NINE MILE POINT NUCLEAR STATION, UNIT 1

AMENDMENT TO FACILITY OPERATING LICENSE

Amendment No. 1  
License No. DPR-63

CHANGE NO. 1 TO TECHNICAL SPECIFICATIONS

Figure 2.1.1 Revised  
FUEL CLADDING INTEGRITY SAFETY LIMIT

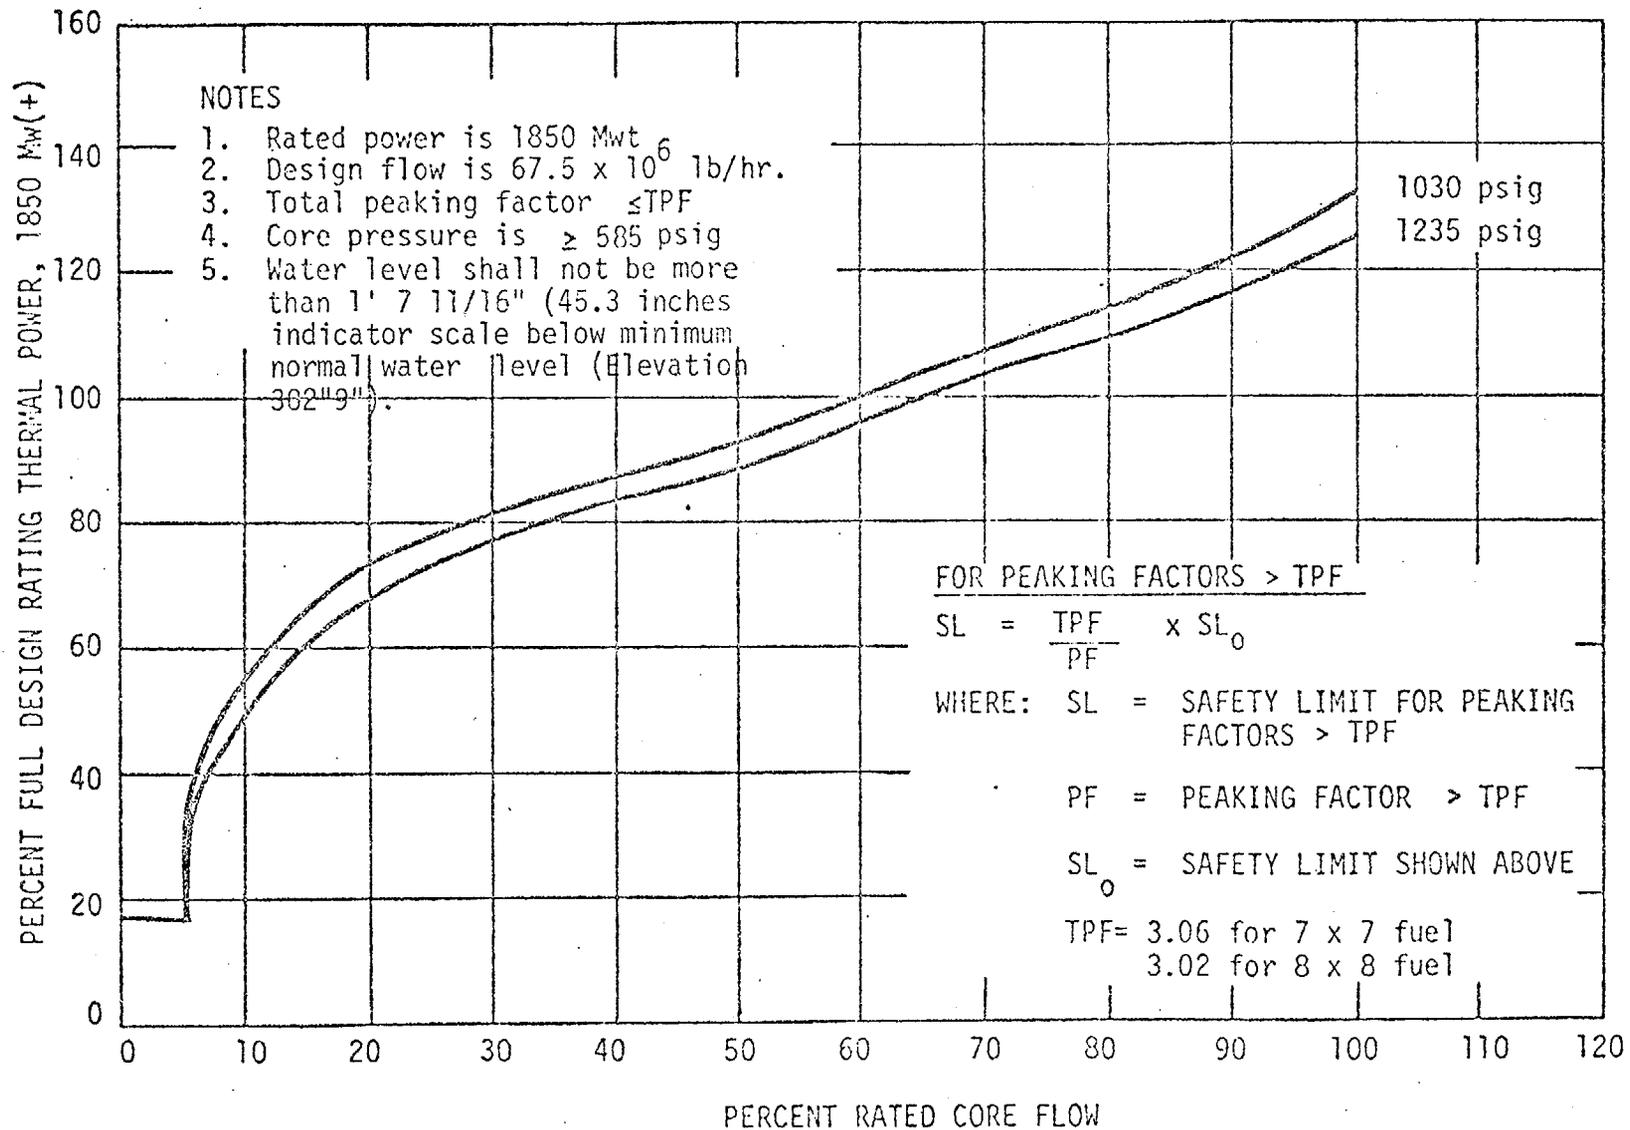
2. A change in the low-low-low water level setpoint from 128" to 127.1" as indicated on the installed instrumentation.
3. Revision of the statements in the Basis regarding the performance requirements for the containment spray raw water cooling system.

A fuel cladding safety limit exists at the low-low-low reactor water level setpoint to assure that sufficient water level is maintained above the top of the active fuel to provide adequate cooling and decay heat removal. The reactor water level at the low-low-low level setpoint is approximately 4'8" above the top of the active fuel. The proposed change to the actual setting of the low-low-low

level setpoint would correct an error which was made in the original setting. The initial setpoint was 7'11" below elevation 302'9" which is equivalent to 128" on the installed instrumentation indicator scale. The corrected setpoint would be 127.1" on the indicator scale. Since the actual water level in the reactor vessel is inversely proportional to the magnitude of the indicator scale reading (i.e., the higher the indicator scale reading, the lower the actual water level in the reactor vessel and vice versa), a change in the setpoint from 128" to 127.1" effectively increases the amount of water present in the reactor vessel at the low-low-low water level setpoint. Therefore, the proposed change would correct an existing error and would slightly increase the margin of safety. In addition, the change does not invalidate the results of current transient analyses since an allowable deviation of  $\pm 2.6$  inches in set point error is assumed in the calculations.

FIGURE 5.2  
NMP-JAF NUCLEAR SITE  
OPERATION ORGANIZATION

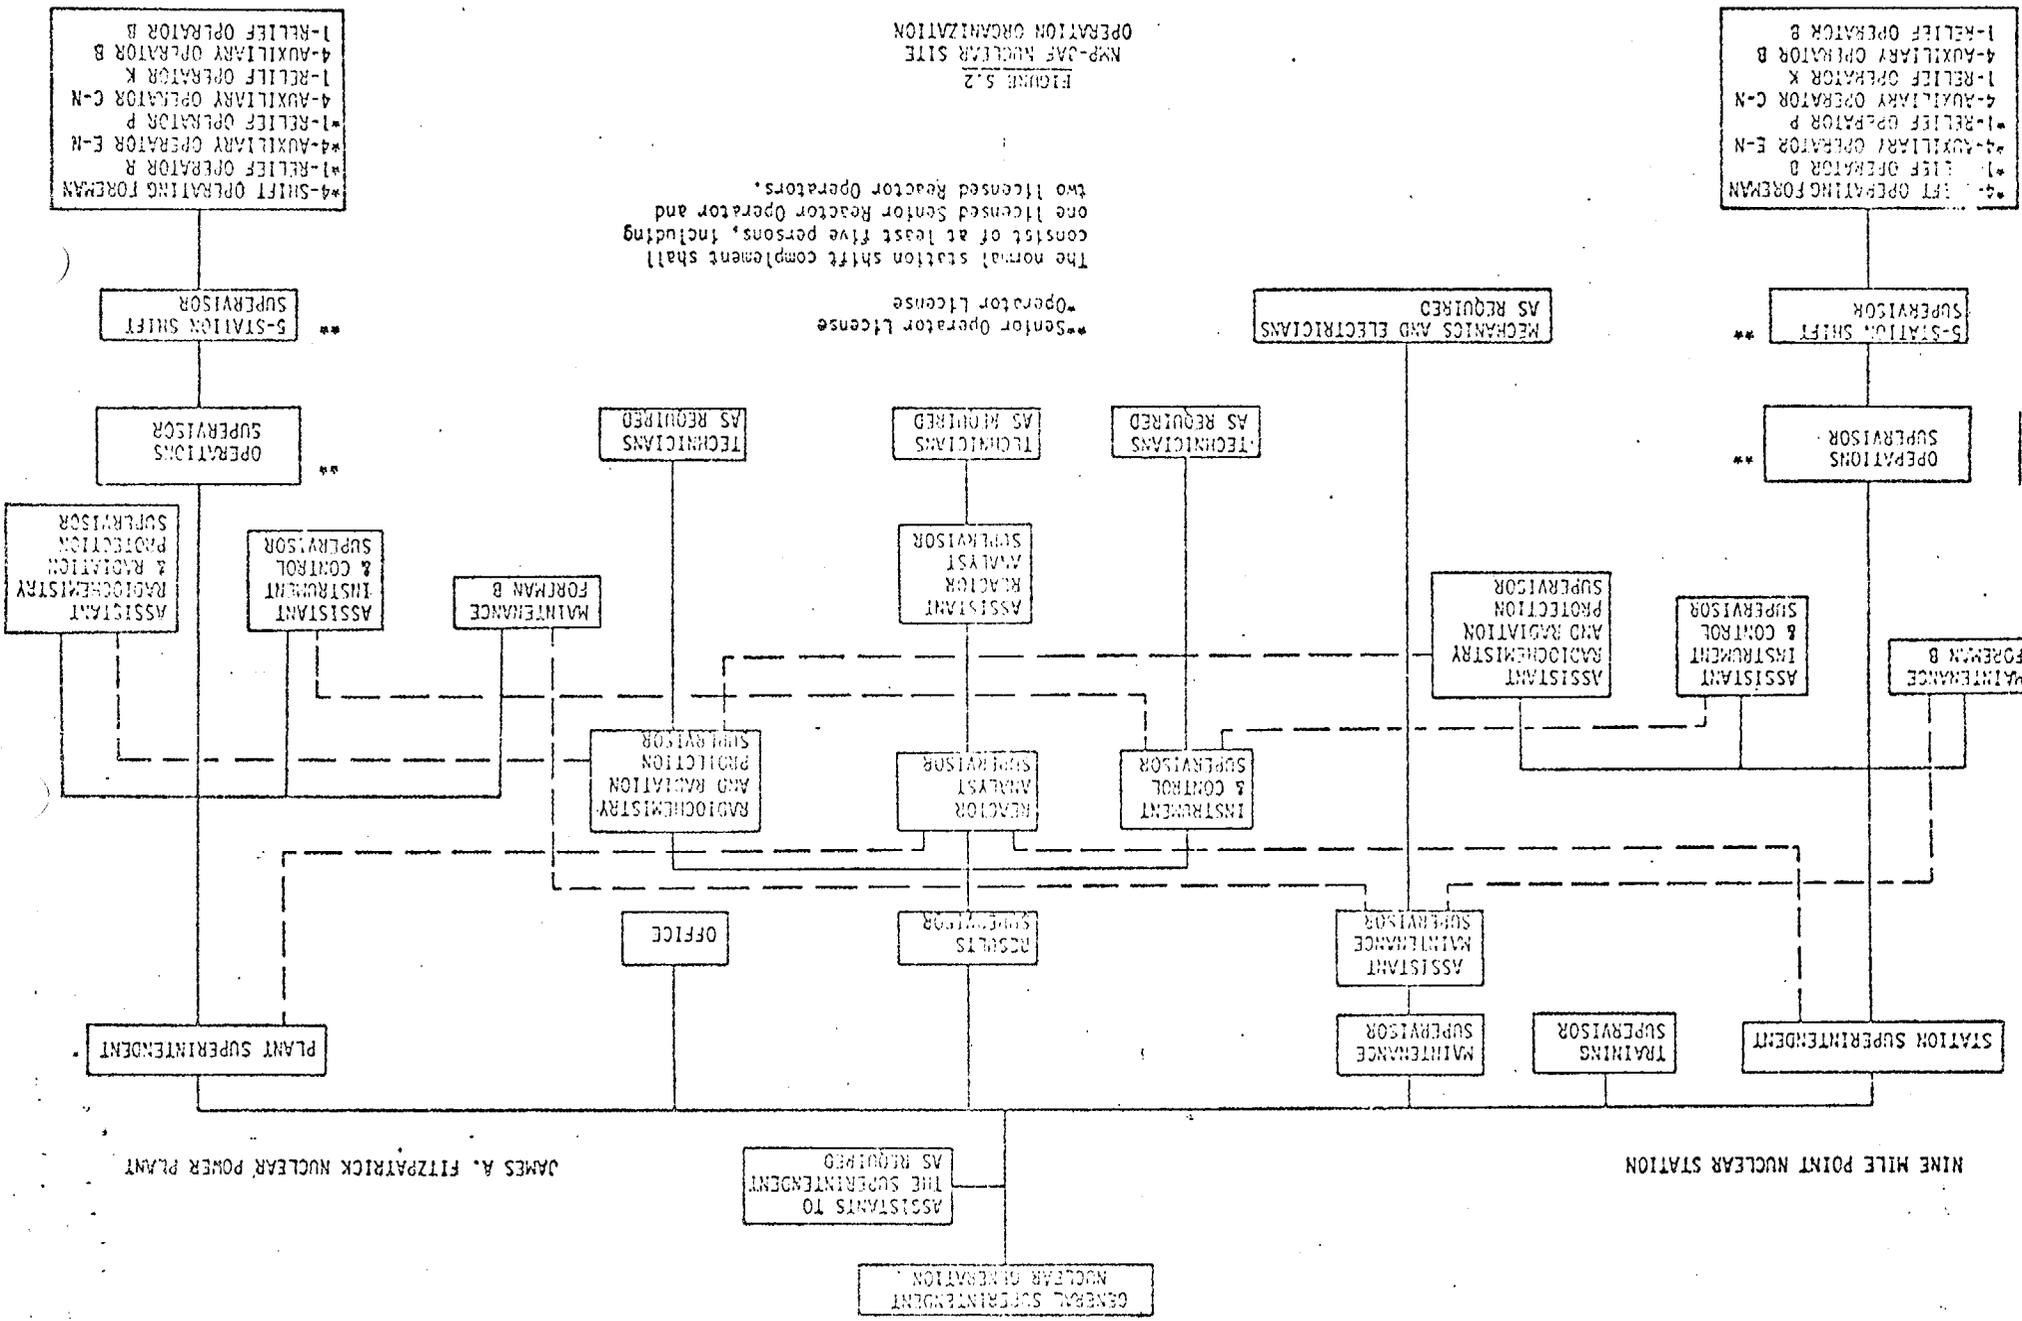
4. A change in the position title of the "Assistant to the Superintendent for Operation" to "Operations Supervisor", and the addition of an "Assistant Maintenance Supervisor" position to the Station organization. These proposed changes would be made in both Appendices A and B to Facility Operating License No. DPR-63.

The proposed change in the Nine Mile Point Nuclear Station Unit 1 organization involves a change in a personnel position title and an addition of a position to the personnel roster. The proposed change in the position title of the "Assistant to the Superintendent for Operation" to "Operations Supervisor" does not change the function of the position and is consistent with ANSI N18.1-1971, "Selection and Training of Nuclear Power Plant Personnel".

The other proposed change involves the addition of an "Assistant Maintenance Supervisor" position to the Station operating organization. The establishment of this additional position reflects the increase in the maintenance workload resulting from the operation of two reactor facilities at the same site.
